TECHNICAL SERVICE BULLETIN

Pop/Sizzle/Crack Noise From Exhaust

21-2335

Ford 2020-2021 Transit

Figure 1

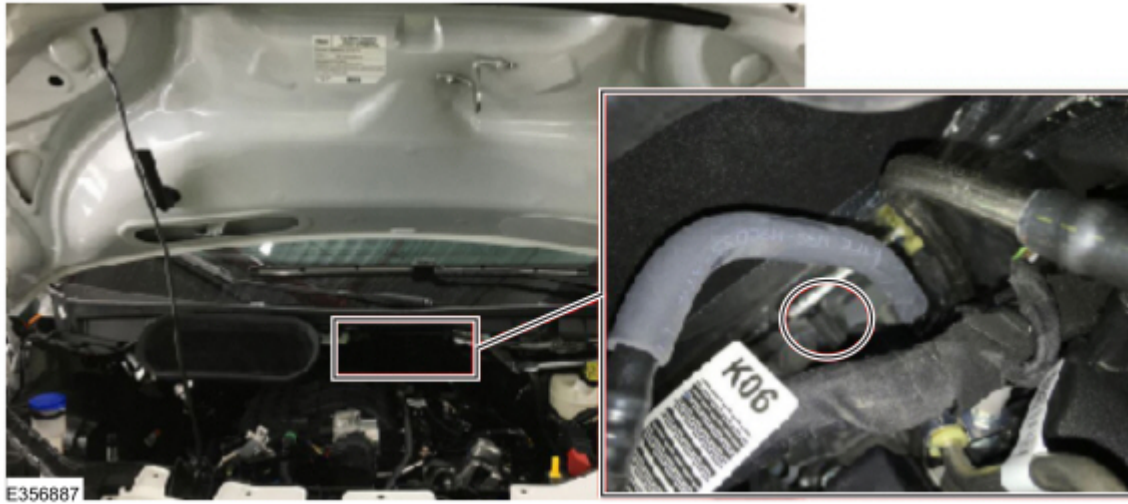
Issue: Some 2020-2021 Transit vehicles may experience a pop/sizzle/crack noise from the exhaust. This may be due to water dripping on the exhaust from the evaporator drain tube. To correct the condition, follow the Service Procedure to extend the length of the evaporator drain tube.

1. Apply a thin coat of Motorcraft® Seam Sealer (Black) to the inside of one end of a locally acquired vinyl tube measuring 5 cm (2 in.) long and an inner diameter of 13 mm (1/2 in.).
2. Install the vinyl tube from the top side of the vehicle to the evaporator drain tube. Use a set of pliers to extend the reach if necessary. (Figure 1)
